UNITED STATES PATENT AND TRADEMARK OFFICE

APPLICATION NO.	FILING DATE	FIRST NAMED INVENTOR	ATTORNEY DOCKET NO.	CONFIRMATION NO.
10/627,491	07/25/2003	Roger D. Peckham	H0004168	4209

Office Action Summary

DETAILED ACTION

FIG. 3

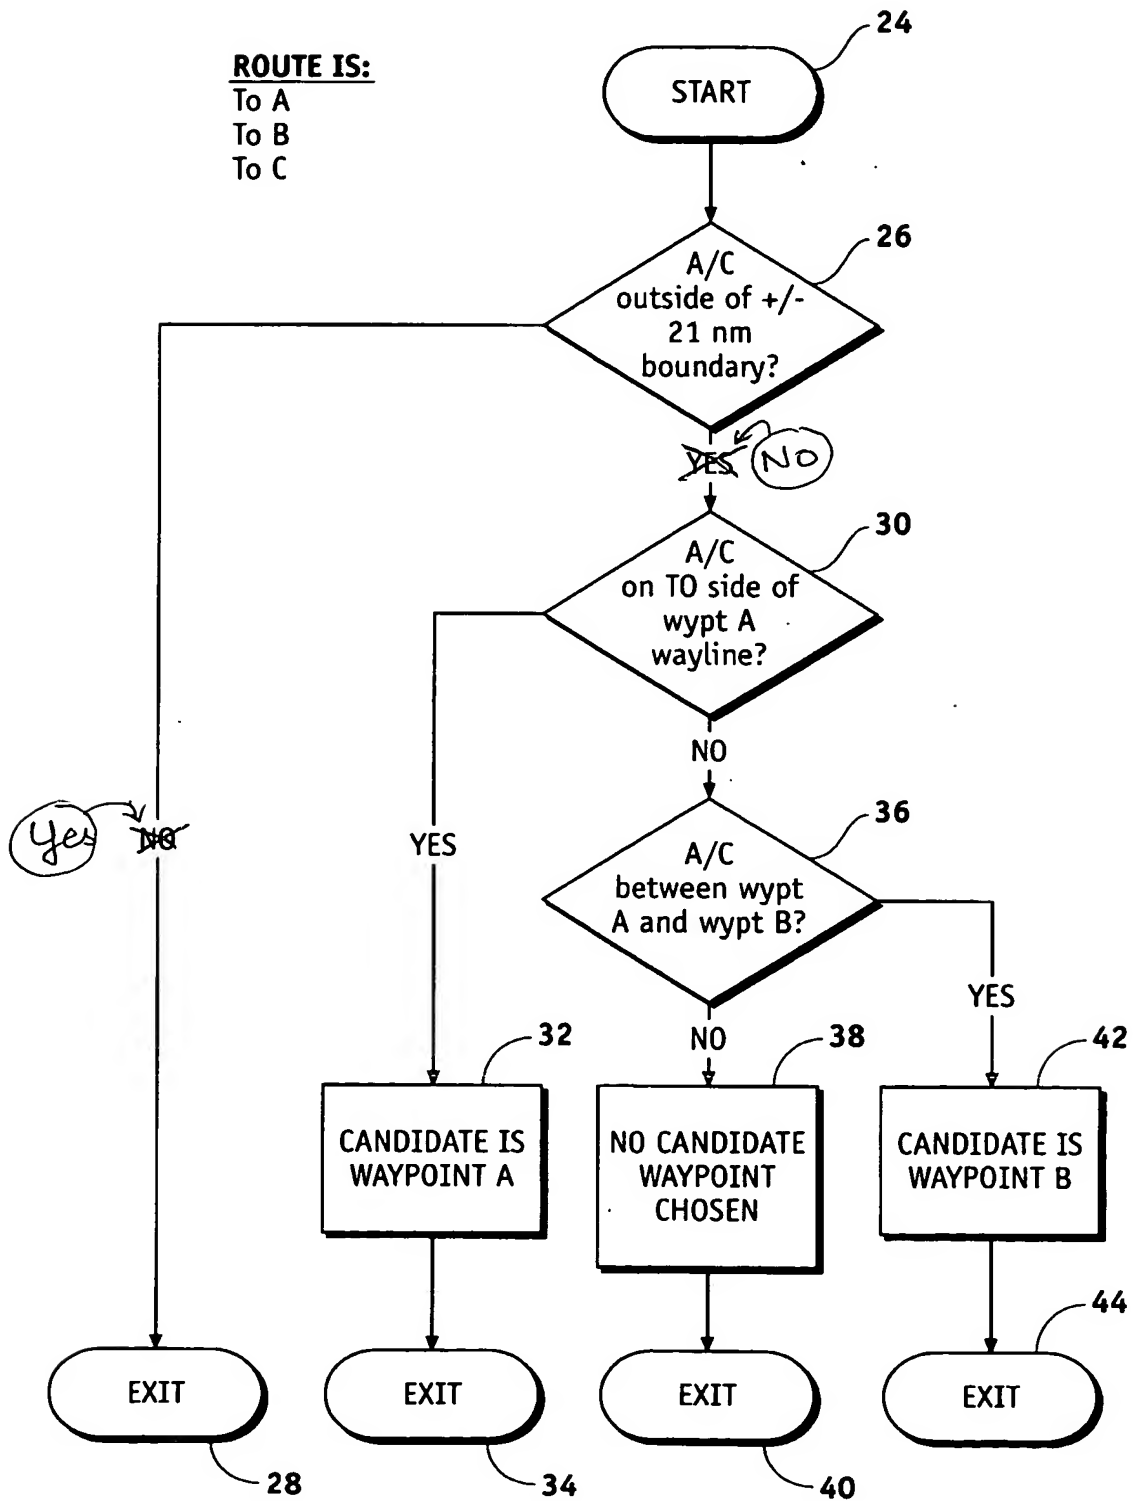
1. In fig.3, after box 26, the arrow indicated "yes" should be corrected to "no" and the arrow indicated "no" should be corrected to "yes" so that the drawing corresponds to the specification disclosed in paragraph 0032-0033.

9. Drawings: the originally filed figured 3 with the branches after box 26 indicated “Yes” and “No” is at the position stated in the proposed drawing correction (to say in other word, there is not any correction in the proposed drawing). Enclosed herein the original drawing fig.3, with the examiner’s suggestion of correction.
